ADDENDUM NUMBER 3

GLEASON DRIVE, CAROLINA DRIVE, EATER DRIVE, GATES DRIVE, AND HARPER DRIVE STORM SEWER AND RESURFACING PROJECT

DATE OF ADDENDUM: JULY 28, 2011

Typical 1/4" Mill, Pvmt. Rem., Pvmt. Widening and 2-1/4" Binder IL 19.0 with 1-3/4" Surf. Course

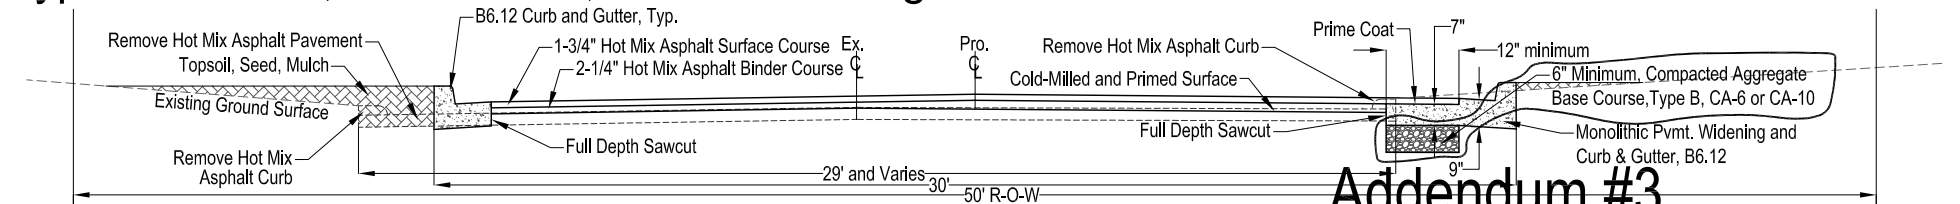
3. On drawing sheet 5, Typical Sections, in the typical section sketch entitled "Typical 1/4" Mill, Pvm. Rem., Pvm. Widening and 2-1/4" Binder IL 19.0 with 1-3/4" Surf. Course", add to the sketch

6" Minimum, Compacted Aggregate Base Course, Type B, CA-6 or CA-10, below the Pavement Widening.

Project 10-00104-00-ST
 Gleason Storm Sewer
 Paving Plan and Storm Sewer Profile
 Addendum #3 07/28/11
 MODIFIED: K.L.H. 06/29/2011
 CHECKED: P.C.P. 07/01/2011
 APPROVED: G.G.H. 07/01/2011

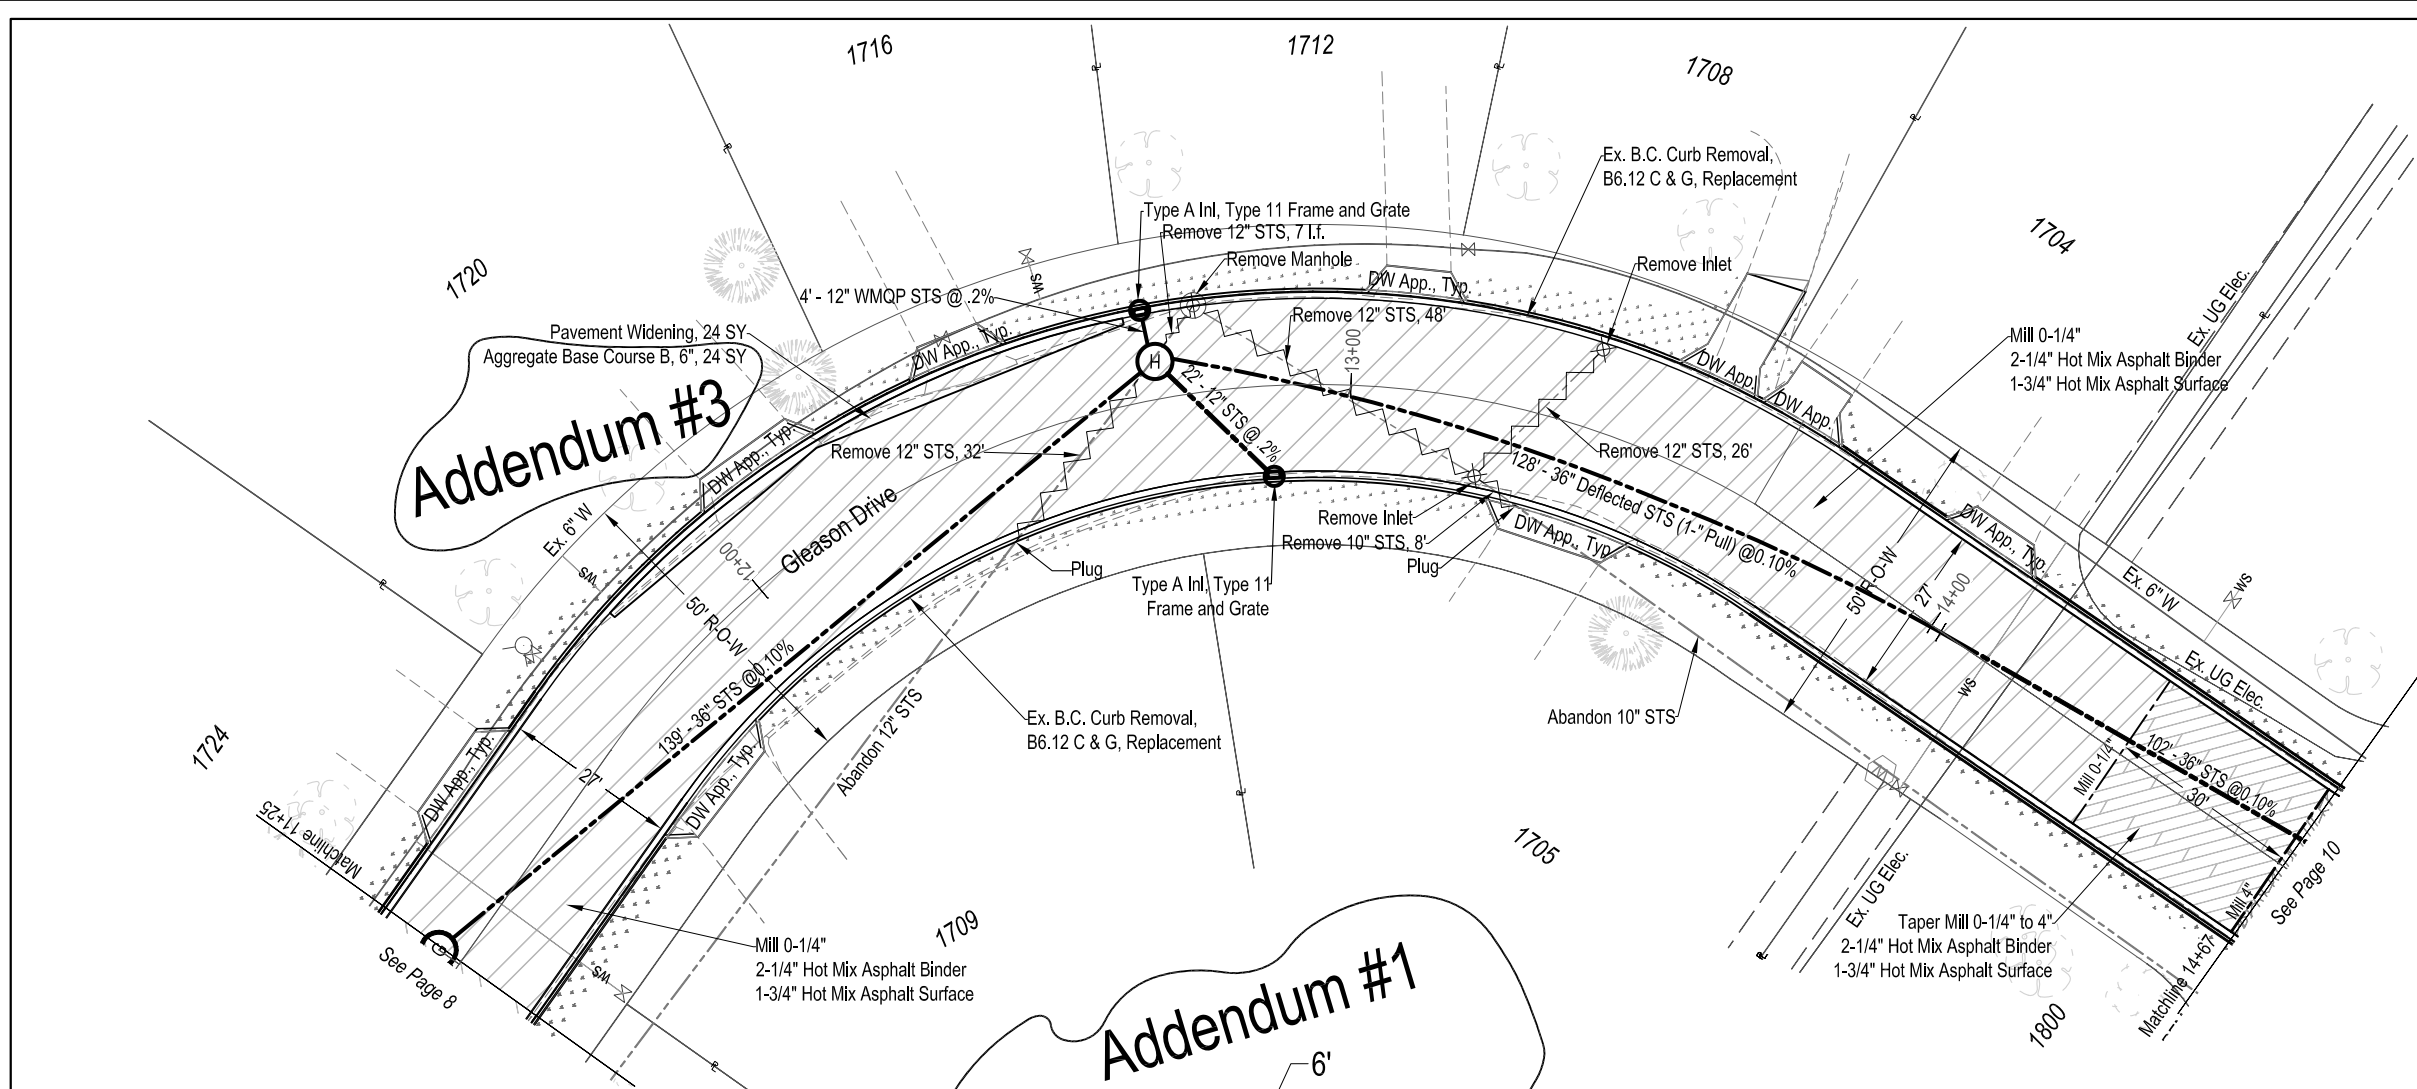
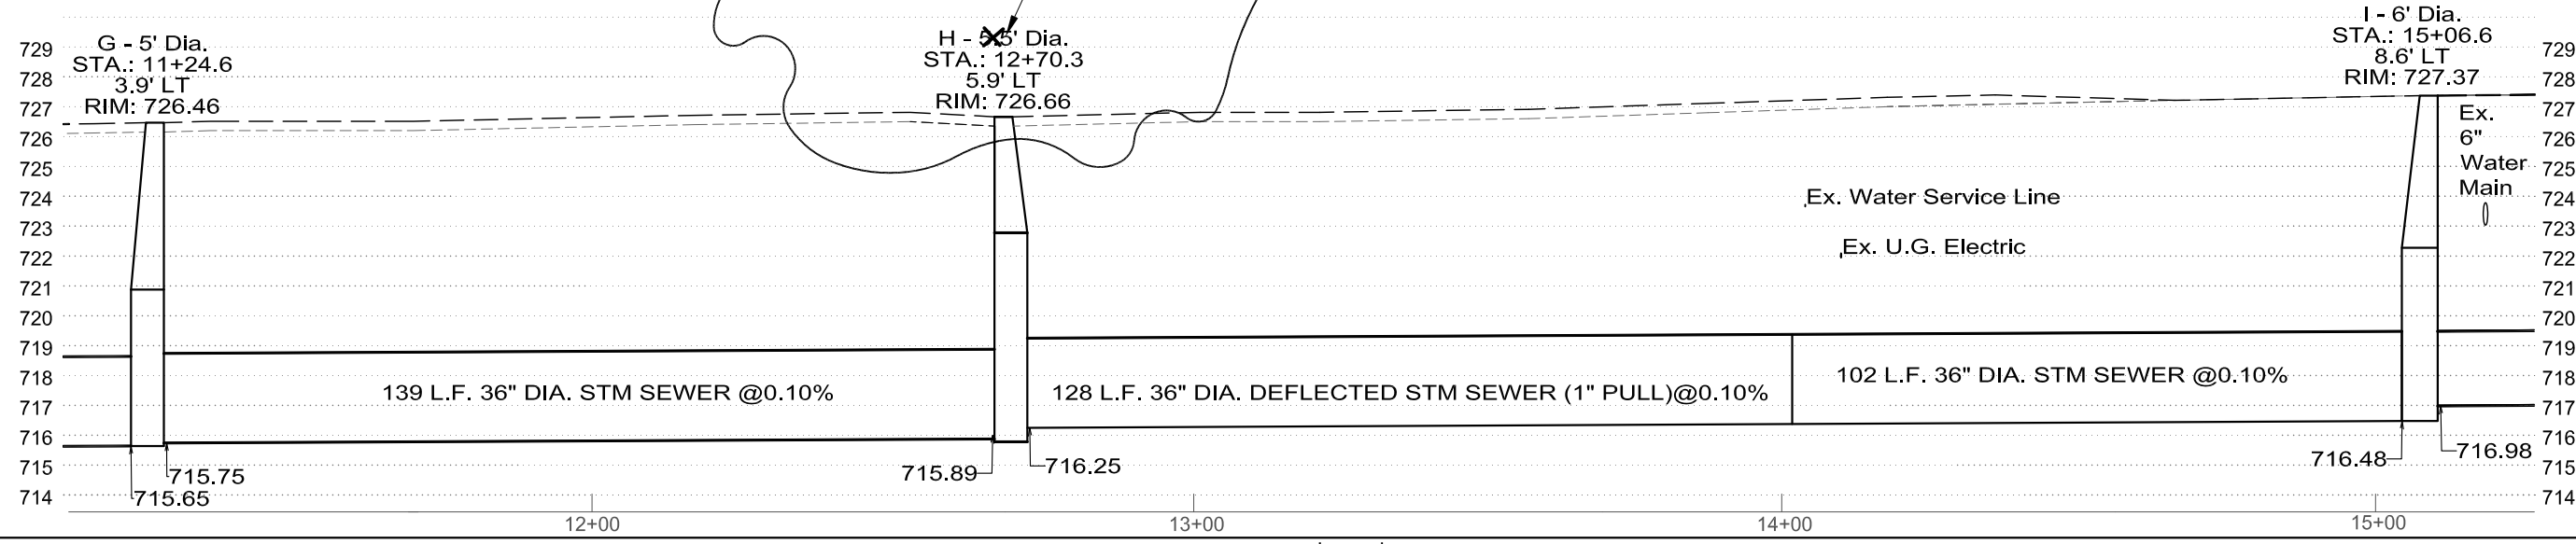
3. On drawing sheet 9, Paving Plan and Storm Sewer Profile, in the plan drawing, adjacent to the curb and gutter in front of 1716 Gleason Drive, change the leader text "Pavement Widening, 24 SY" to "Pavement Widening, 24 SY Aggregate Base Course B 6", 24 SY"
